WATER DISTRIBUTION SYSTEM

Lot 2, Block 2, Wichita Builders 3rd Addition

Project Number
2122 PPW (183021)

AS BUILTS

LTC Custer
Fire line - Plan and Profile
Wichita, Kansas

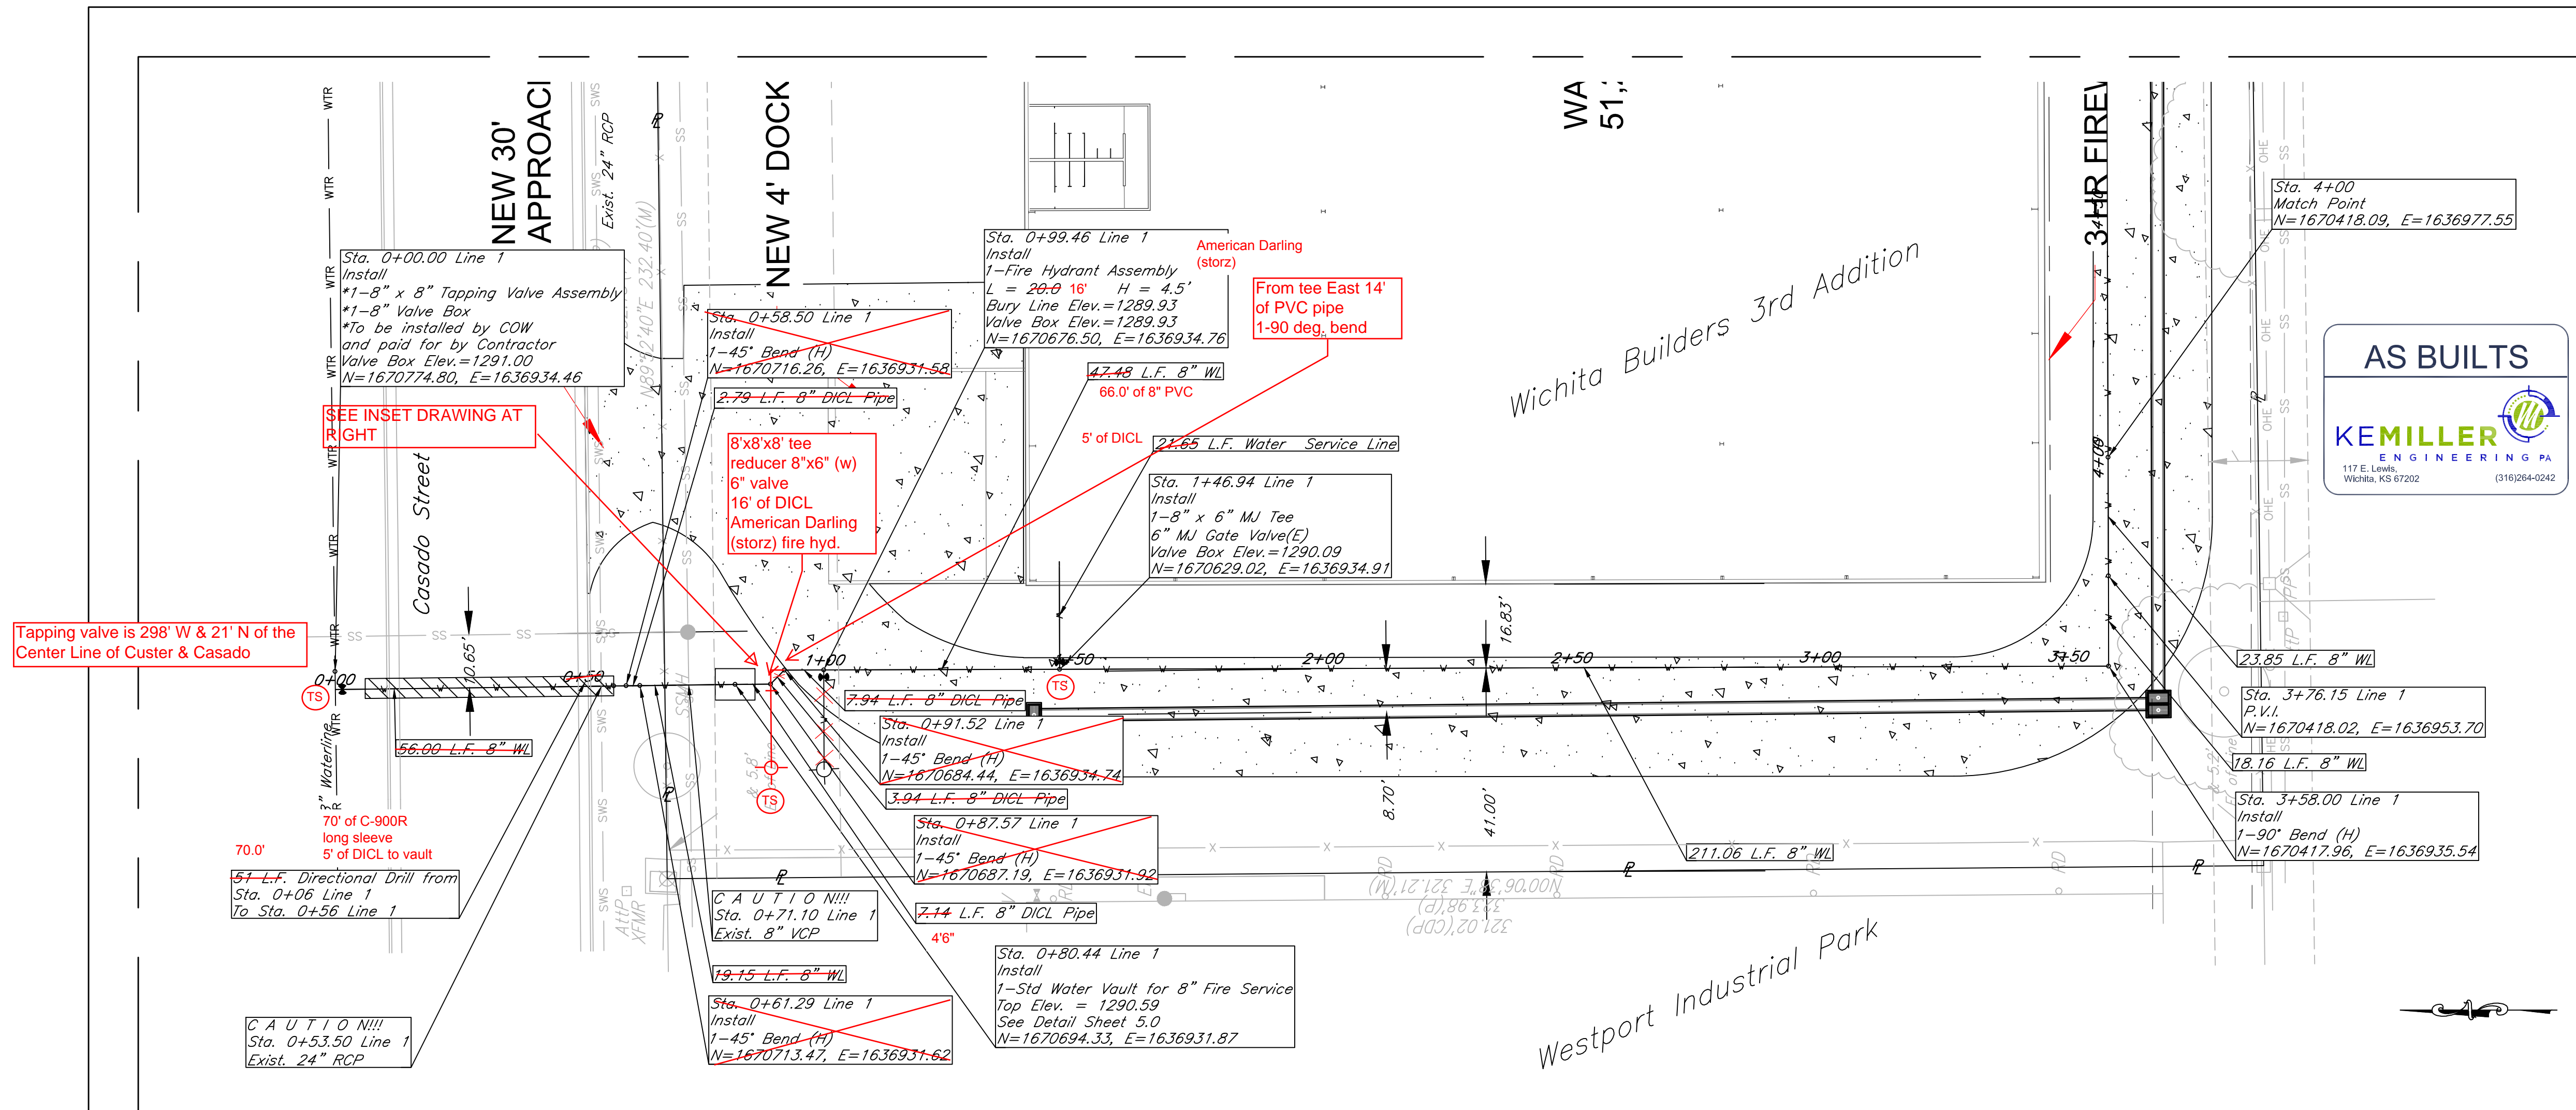
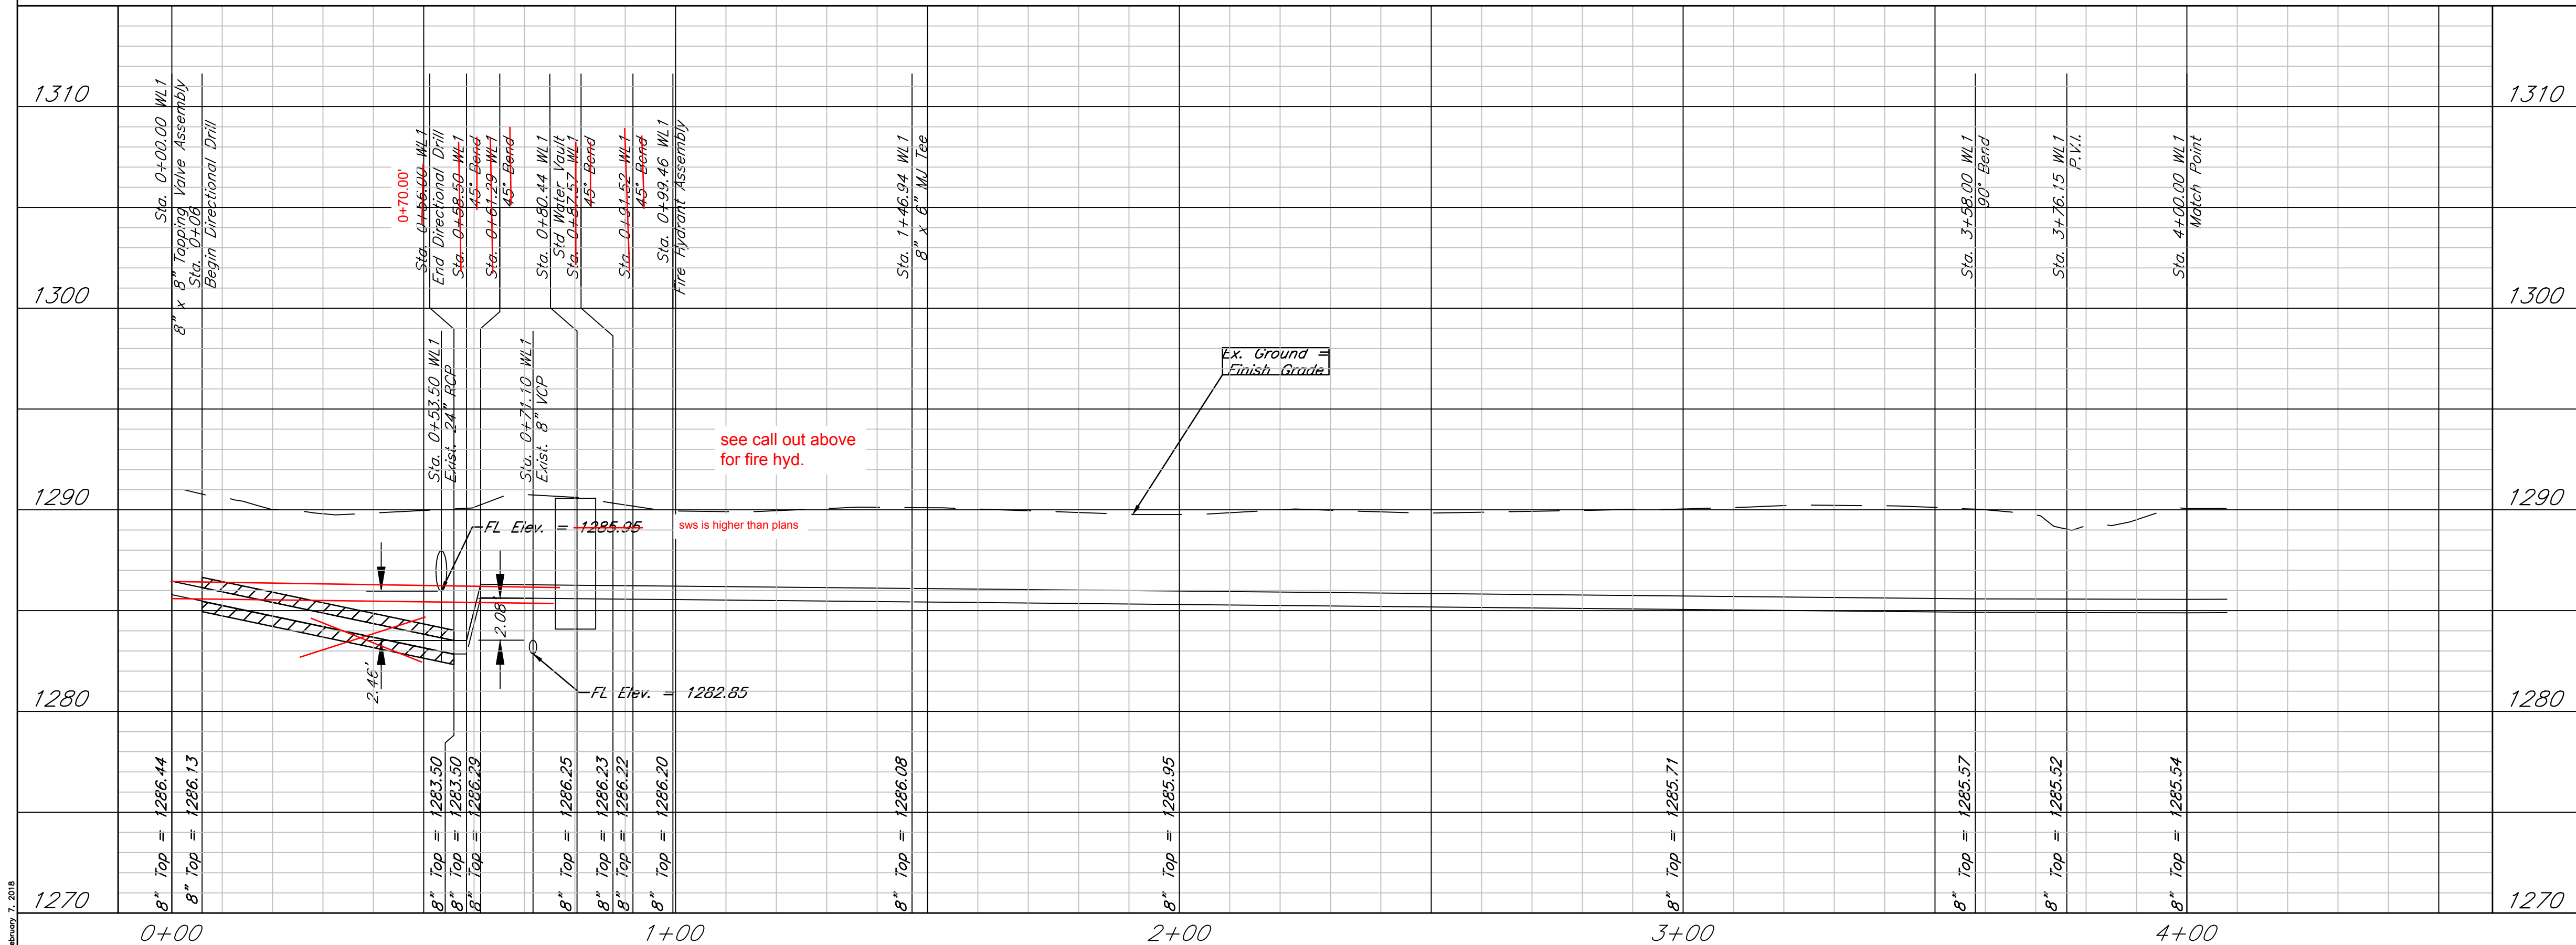
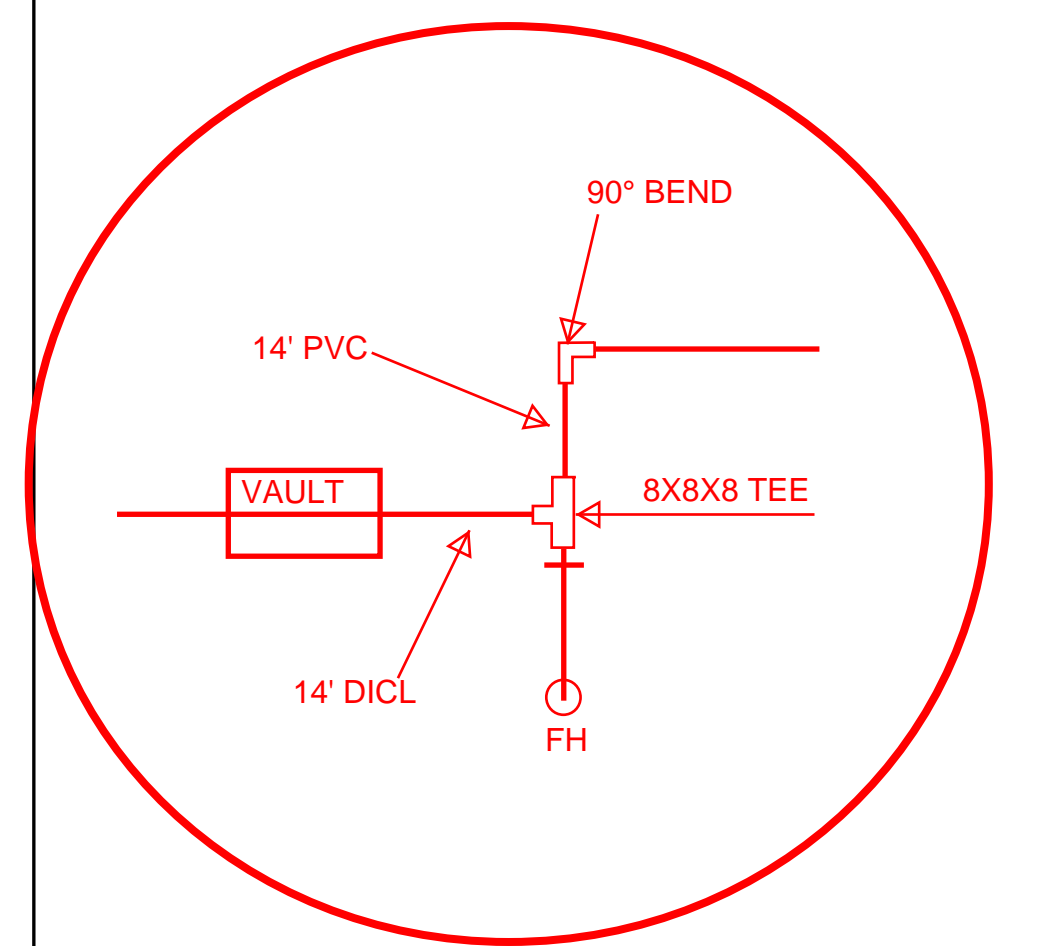
Tapping valve is 298' W & 21' N of the Center Line of Custer & Casado

70' of C-900R long sleeve 5' of DCL to vault

From tee East 14' of PVC pipe 1-90 deg. bend

8"x8"x8' tee reducer 8"x6" (w) 6" valve 16' of DCL American Darling (storz) fire hyd.

FL Elev. = 1295.05 svs is higher than plans
